REMARKS

Serial No. 10/038,946 Docket No. BUJ 005 P2

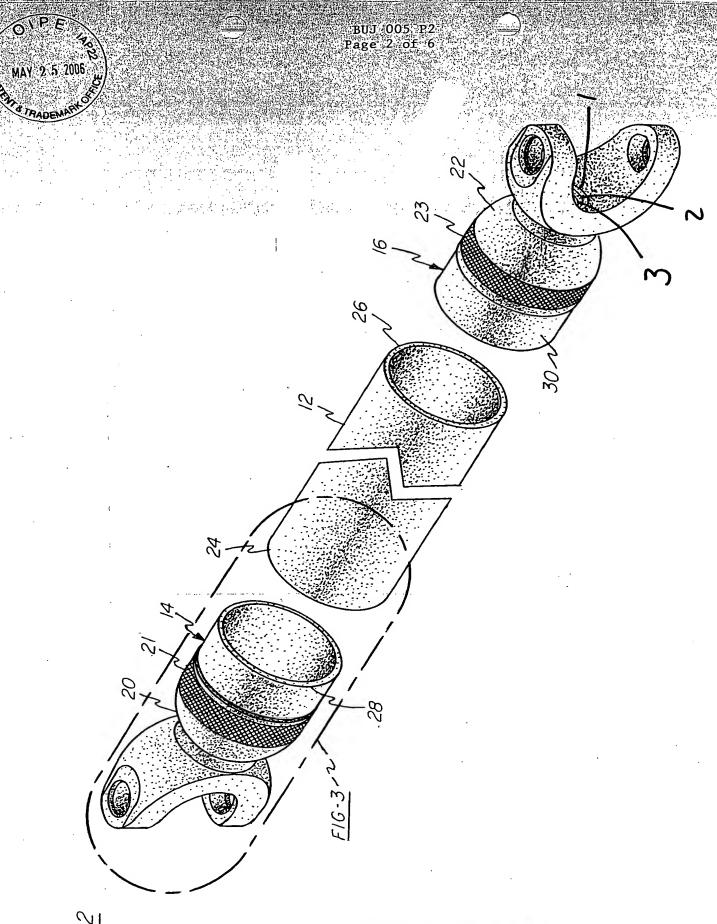
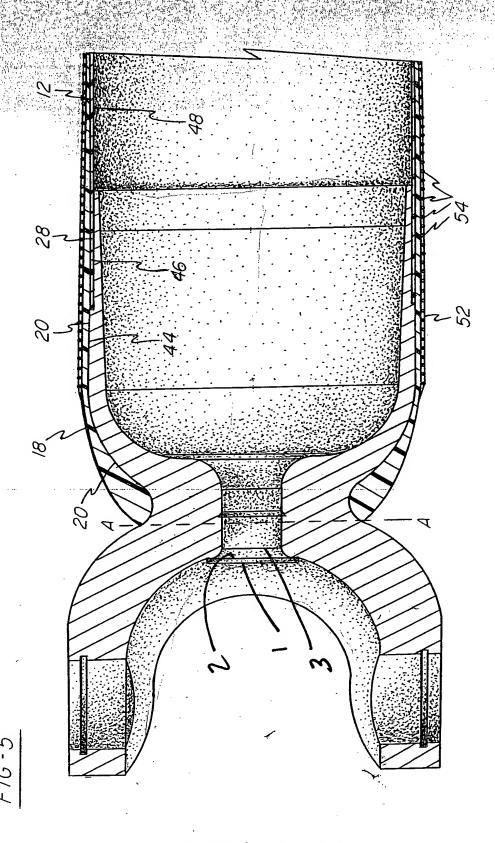
The Examiner has objected to the drawings, stating that they fail to show the "geodesic isotensoid elliptical shape derived with reference to the angle of the fibers" recited in claim 8 & 13 and similarly recited in claim 17 due to what the Examiner perceives to be a contradiction by the inventor in item 6 of his declaration filed June 3, 2005. While Applicant submits that there is no contradiction with respect to item 6 of the inventor's declaration, claims 8, 13, and 17 have been amended, and as amended the grounds for this objection are submitted as being moot, such that the objection to the drawings should be withdrawn.

Turning now to the rejections under Section 112, first paragraph, claims 17-20 were again rejected due in part to problems with the original drawings. While the Examiner conceded that in the application as originally filed there appears to be a written description of the shaft having open ends, the Examiner states that the solid lines in Fig. 5 as originally filed indicate structure which closes off the opening. To assist the Examiner, red-inked copies of Figs. 1, 2, and 5 of the

original drawings and of the replacement sheets are submitted. Each drawing figure features redinked numbers 1, 2, and 3 which correspond to lines depicting the opening of the shown end of the shaft of the invention. As such, it is submitted that a careful comparison of the various drawing figures result in the conclusion that the solid lines shown in the replacement drawings and discussed by the Examiner in paragraph 4 of the instant Office Action clearly do not close off the opening of the shaft, and that therefore the rejection of claims 17-20 under Section 112, first paragraph, referenced in enumerated paragraph 4 should be withdrawn.
